ADDENDUM NO. <u>1</u>	DATED <u>8/16/2004</u>	ADDENDUM NO. _____	DATED _____
ADDENDUM NO. _____	DATED _____	ADDENDUM NO. _____	DATED _____

Number	Description
1	Section - 904 -Notice to Bidders No. 134 - Scope of Work dated 8/09/2004 replaces one dated 7/12/2004; Section 904- Notice to Bidders No. 141 - Detail of Overlay at Bridge Sites dated 8/09/2004 replaces one dated 7/09/2004; Section 905 - Proposal Sheets 2-1 & 2-6 replace ones now in proposal; progress schedule replaces same one now in proposal; this project requires an updated diskette.

**PROJECT: MP-2007-22(001) / 302372 -- Grenada County**

**SECTION 904 -NOTICE TO BIDDERS NO. 141**

APPROXIMATE LIMITS OF PROJECT  
MP-2007-22(001)  
GRENADA COUNTY

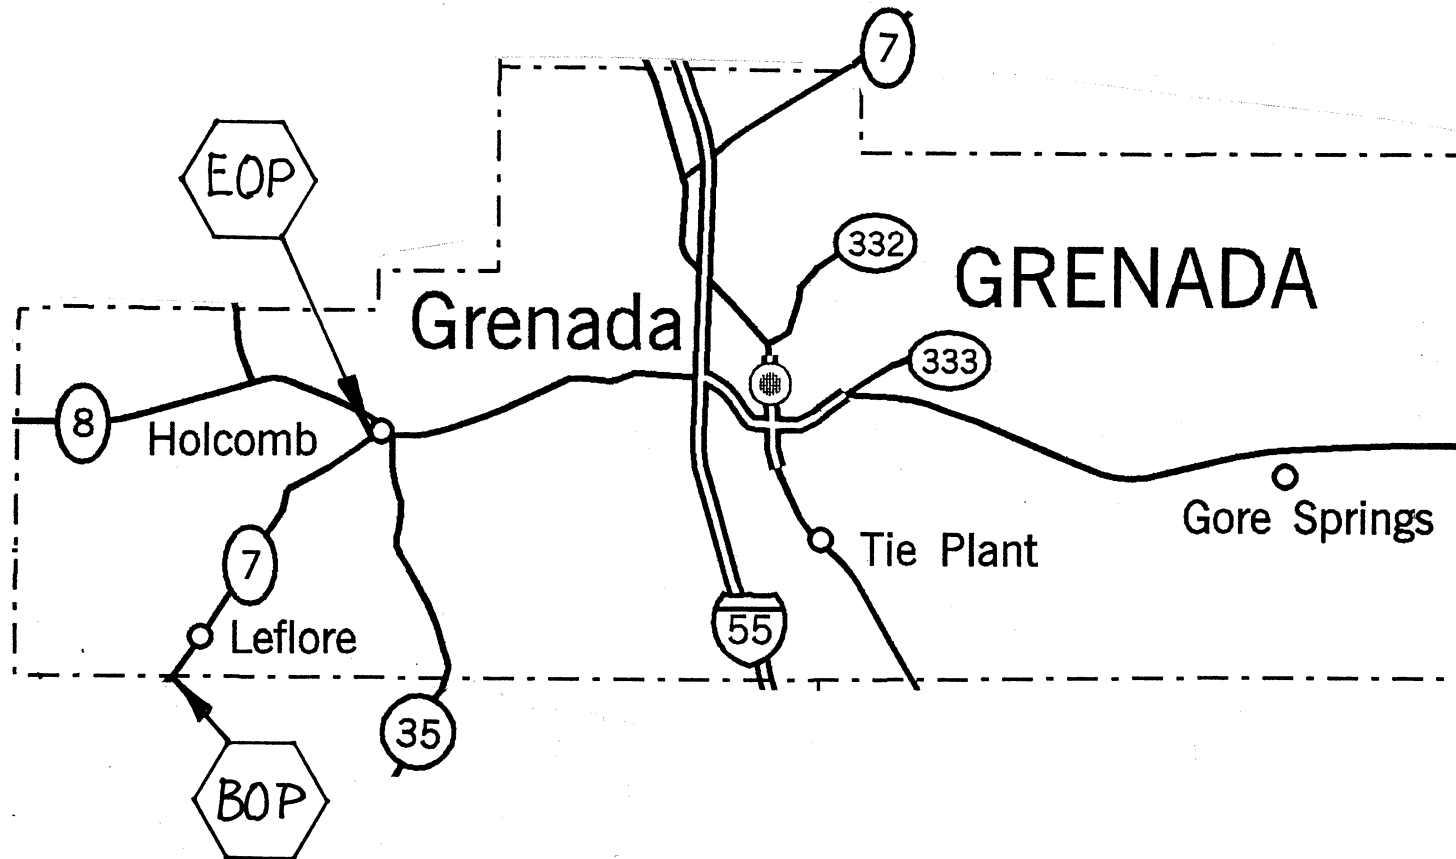
4. Place three (3) inches of trench widening (ST, 19mm) in the previous excavation.
5. Place a one (1) inch and variable depth pavement course (HT, 9.5 mm Polymer-modified) on the twenty-four (24) feet of existing pavement and the two (2) feet of trench widening each side. **Note:** The slope of the surface shall be established as 1.75 % by placing one (1) inch of asphalt at the pavement edge and varying the thickness toward the centerline.

6. Place a one and one-half (1½) inch and variable depth pavement course (HT, 9.5 mm Polymer-modified,) on the twenty-four (24) feet of pavement and the two (2) feet of trench widening each side previously placed. **Note:** The slope of the surface shall be established as 2.00 % by placing one and one-half (1½) inches of asphalt at the pavement edge and varying the thickness toward the centerline.

**DETAIL OF OVERLAY AT BRIDGES**

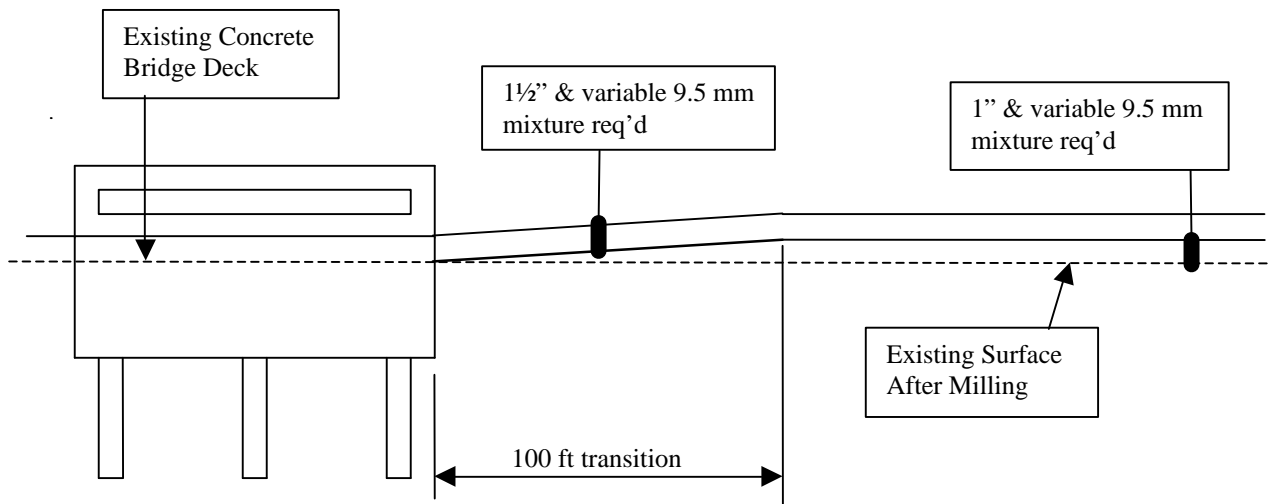
**Note:** At bridge sites the bottom pavement course will stop along the existing travel lanes, as shown in a Notice to Bidders titled Detail of Overlay at Bridge Sites.

**Note:** Bridges will be overlaid with the top pavement course as shown in a Notice to Bidders titled Detail of Overlay at Bridge Sites. The cross-slope of overlay shall match the existing bridge cross-slope.

Overlay at the existing bridges shall be as shown below.
